Report of the East Campus Subcommittee - November 20 2000

Marcia Barrett, Monica Moss, Ed Stephenson

Figure 1. Proposed site maps of Student Recreation Center expansion, Varsity Tennis Facility Relocate Rugby Field, Capstone Medical Center, Game Day Welcome Center.

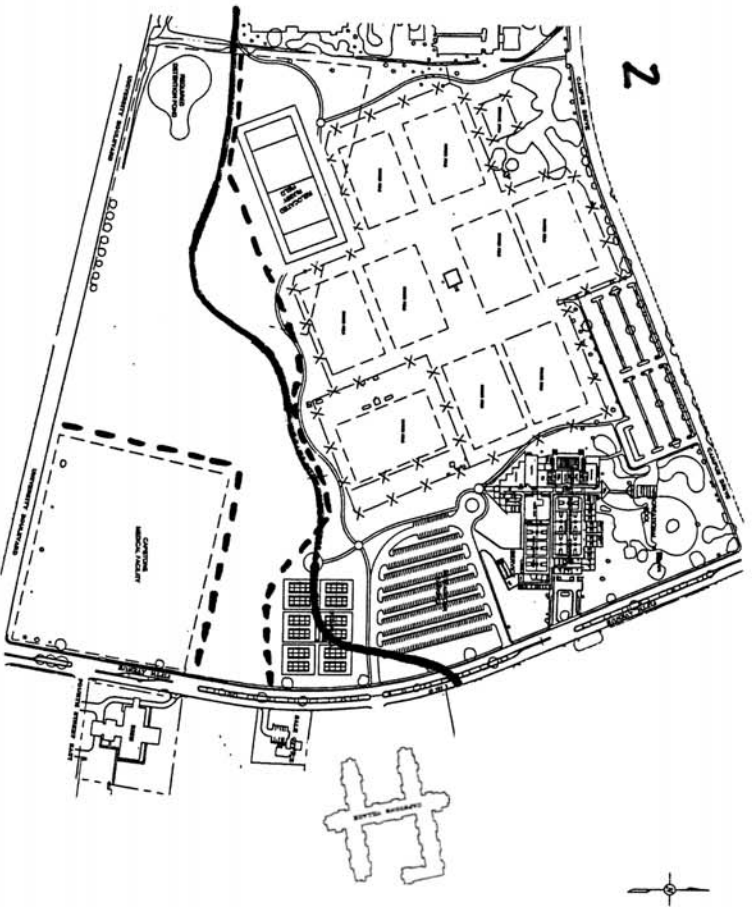
The East Campus Subcommittee has compared the site maps of the proposed Student Recreation Center expansion and the Capstone Medical Center with the 1999 Campus Master Plan. In the following, we assume that the proposed "Game Day" project has been denied and that the proposed rugby field will be located in an area contiguous to the Recreation Center fields, perhaps adjacent to the intramural soccer fields at the west side of the area (see Figures 1 and 2).

We find that the Recreation Center expansion respects the spirit of the 1999 CMP. Although the boundaries are not precisely those envisioned in the Master Plan, the total land area of the SRC expansion approximates that envisioned for developed areas in the 1999 Master Plan. The Capstone Medical Center intrudes significantly into the designated green space, but as this site has already been approved for the Capstone Medical Center and planning is well under way, there is not much that we can do about it.

1. The University should preserve a continuous corridor of green space that runs from 5th Avenue (between the new Medical Center complex and the new intramural tennis courts) to the corner of Bryce Lawn Drive and University Blvd. The undeveloped, semi-natural status of the green space is unique on this campus and should be preserved as a high priority. Future development of this area, except as needed to preserve its semi-natural character, should be prohibited.

2. The University should undertake limited improvement of the green corridor, installing unpaved walking paths, but otherwise the corridor should be reserved as a minimally-maintained green space.

3. The University or City of Tuscaloosa should install paved and lighted sidewalks along the north side of University Blvd between 5th Avenue and Bryce Lawn Drive.

4. The University recognizes that the prohibition against further development within the green corridor means that Athletic Department facilities tentatively proposed for this area (a tennis complex in recent site maps and track and field facilities in the 1999 Campus Master Plan) must be located elsewhere.

5. In planning the Capstone Medical Center, the University should accommodate the continuity of the green corridor by minimizing the depth of the facility away from University Blvd, perhaps by increasing its frontage along University Blvd.

6. In planning the new Recreation Center parking lot and intramural tennis courts, the University should accommodate the continuity of the green corridor by siting these facilities as far north as practical.
